# Addendum Number 3 January 29, 2021

Headhouse Renovations
Southern University and A&M College
Baton Rouge, Louisiana 70813

#### **HEADHOUSE RENOVATION**

**Architects Project No. M19-003**

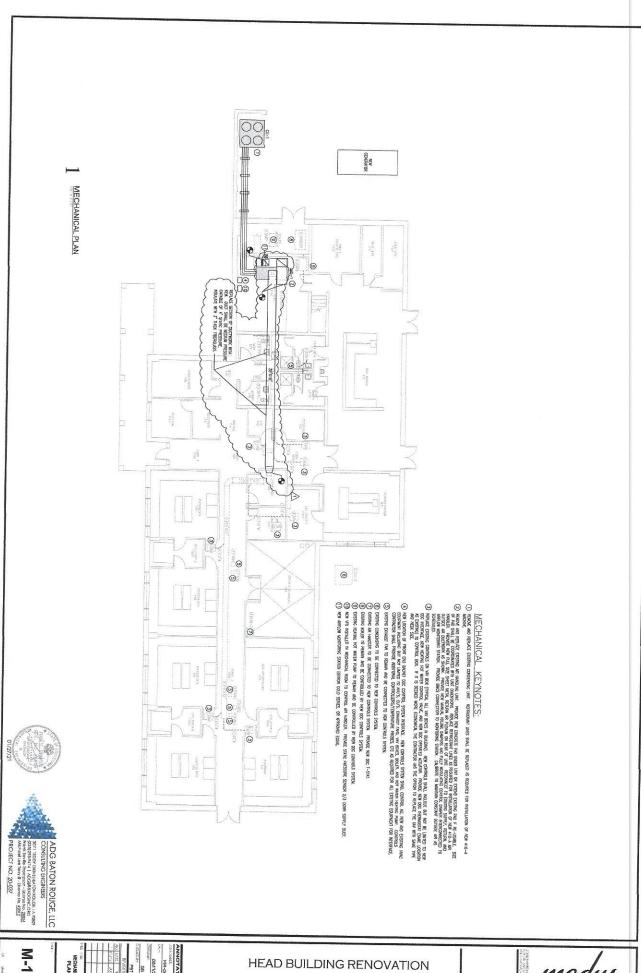
2. I have a request from one of the walk in cooler subs needing more details, particularly dimensions. Could you provide additional information.

The dimensions of the three coolers are approximately (field verify):

12'-8 ½" x 12'-10"

5'-1 1/2" x 12'-10"

5'-3" x 17'0"
